A-1-MEN-07-047

McCONNELL

PLANNED MC CONNELL RESIDENCE
14820 NAVARRO WAY
IRISH BEACH, MANCHESTER,
MENDOCINO COUNTY,
CALIFORNIA

A-1-MEN-07-047 - McCONNELL
U.S. FISH & WILDLIFE SERVICE
LETTER & RESTORATION
PLAN FOR 2008 IMPACTS TO
DEED RESTRICTED PAMB
HABITAT (1 of 12)

Figure 1. Bluff edge as approved for the northerly adjacent parcel in 1991.

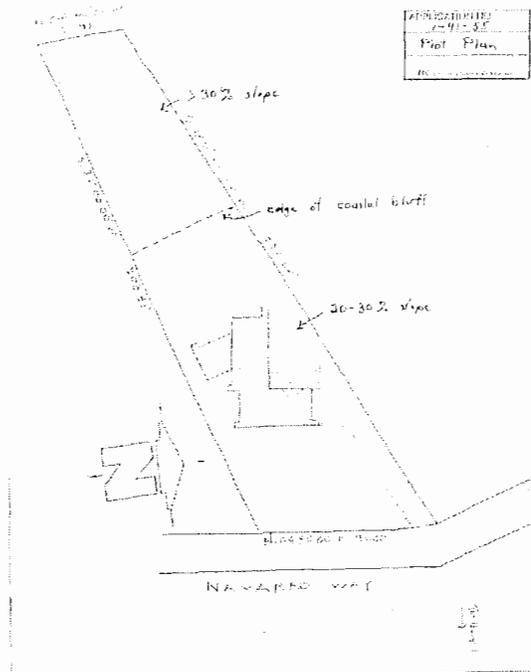
The proposed residence placement is in line with existing residences to the immediate north and south of the parcel. According to assessor's records, the residence to the immediate south (APN 132-020-06) has been in existence since 1972, predating the Coastal Act. The residence to the immediate north (APN 132-020-04) was approved by the Coastal Commission in 1991 (permit 1-91-55). The project was approved with a 50 foot geological setback requirement. The residence was to be set back approximately 57 feet from the bluff edge, which was determined at that time to be approximately 176 feet south of Navarro way on the property line adjacent to the subject parcel (see Figure 1).

Relative to the subject project, this bluff line would be located approx. 50 feet from the proposed residence (see Figure 2.).

Figure 2. Map modified by staff showing approximate location of bluff edge as approved by CC 1-91-55.

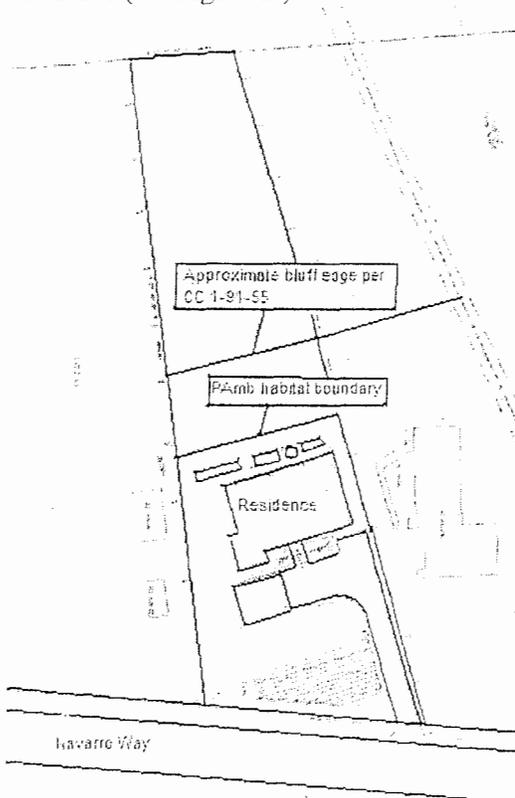
Staff spoke with Dr. Johnsson regarding the inconsistency between the bluff line approved by the Coastal Commission in 1991 for the adjacent parcel and his assertion that the bluff line is closer to Navarro Way. Dr. Johnsson explained that his determination regarding the bluff line location is based on application to the specific parcel of the Coastal Commission definition from the California Code of Regulations, Title 14, Section 13577:
